BULLETIN # 3 4

PROJECT: Harrison Recreation & Community Center – PHASE 2
Harrison, NY

RE: Remove AV Components at Room 106B

Sheet Number
AVV102

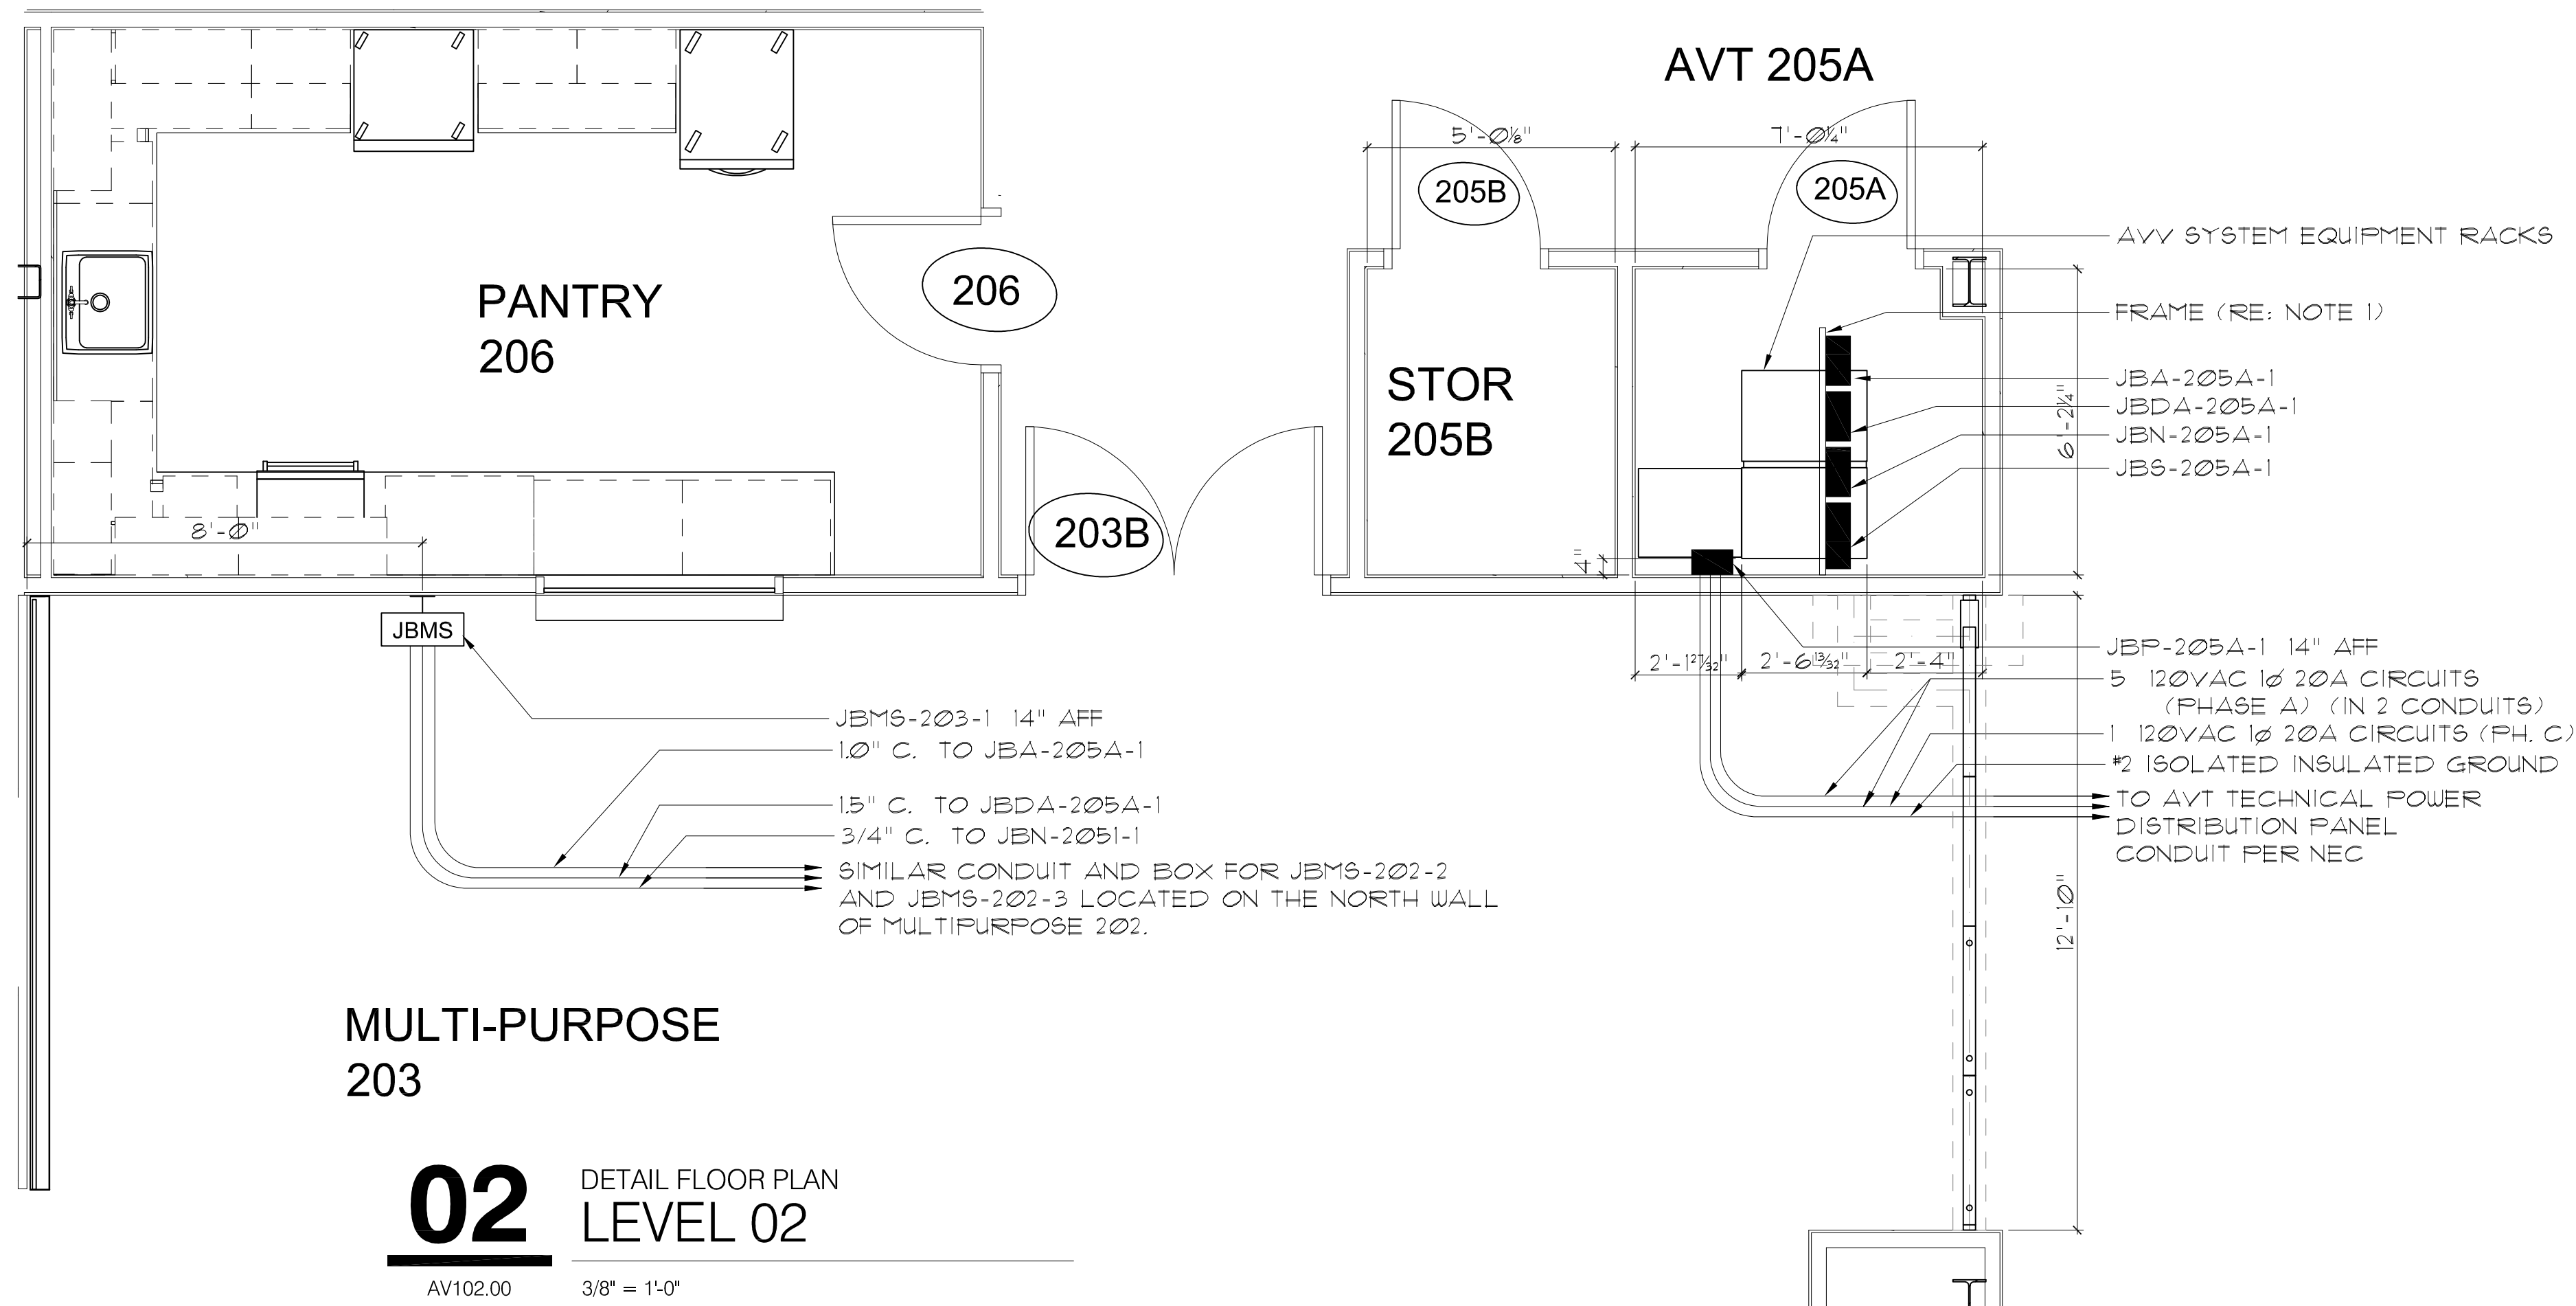
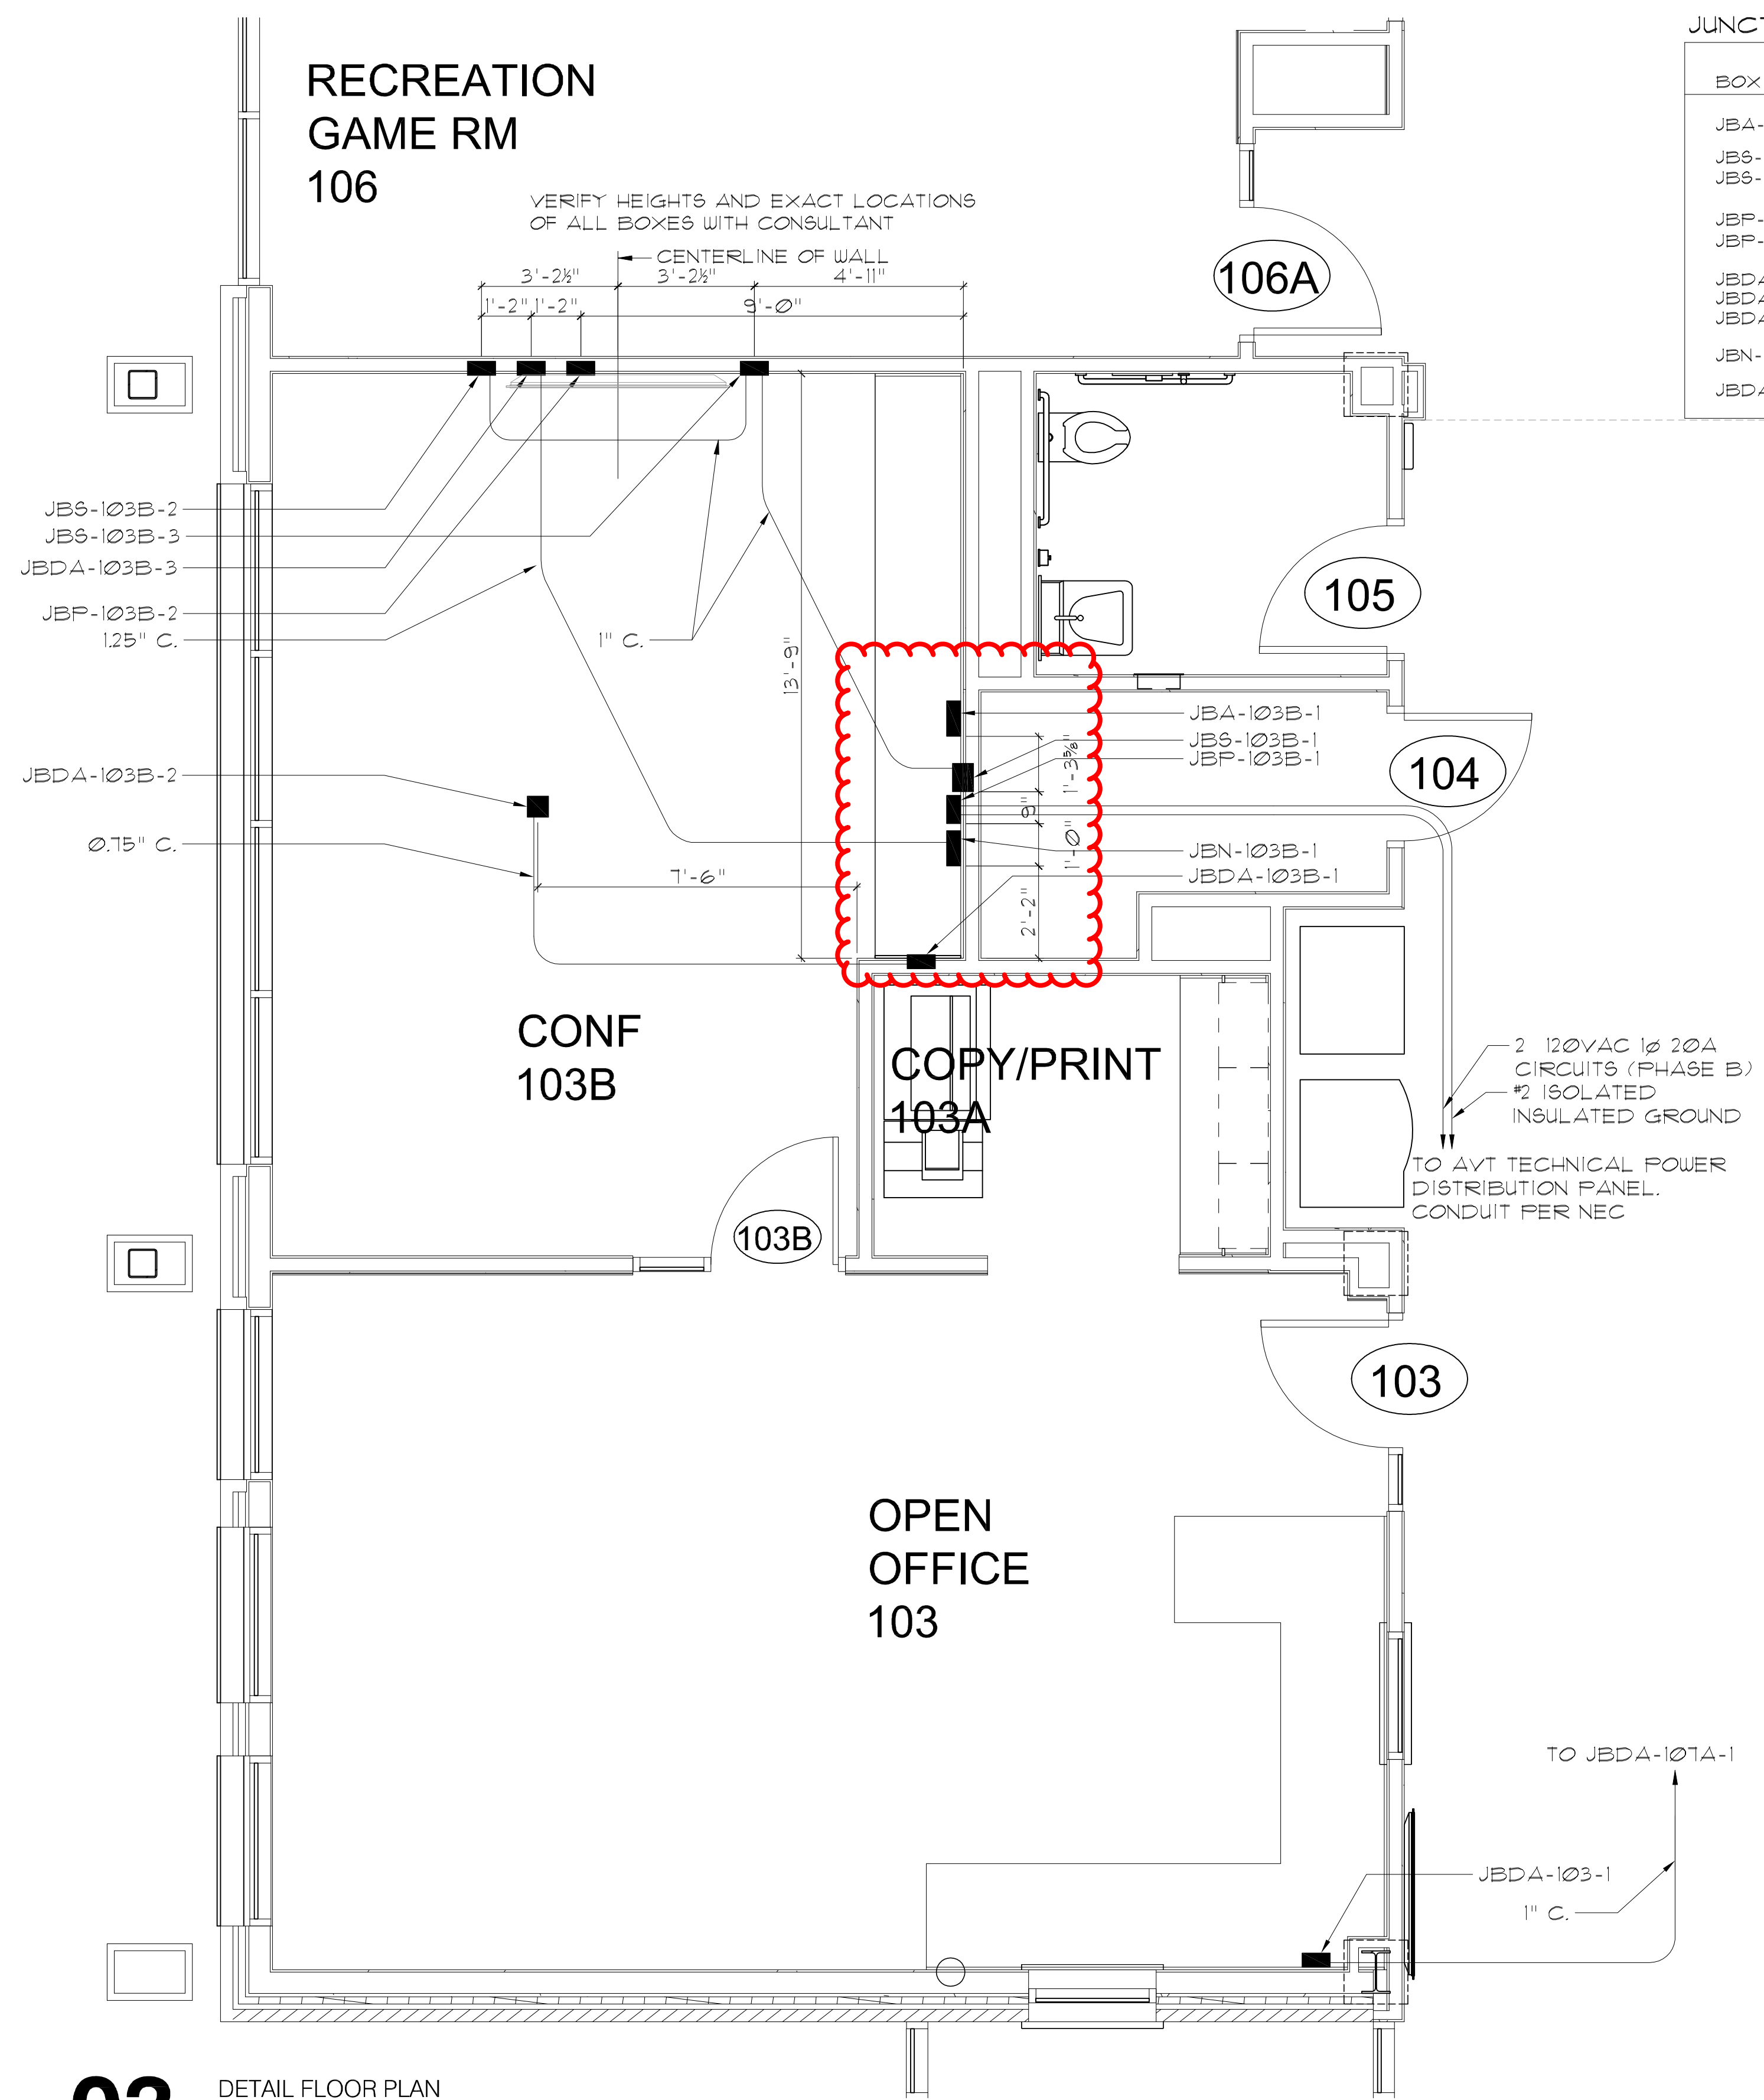
On the north wall of Room 106B remove the AV components installed in the wall that are projecting out past the face of the drywall to allow for the installation of the casework as shown on the attached mark up.
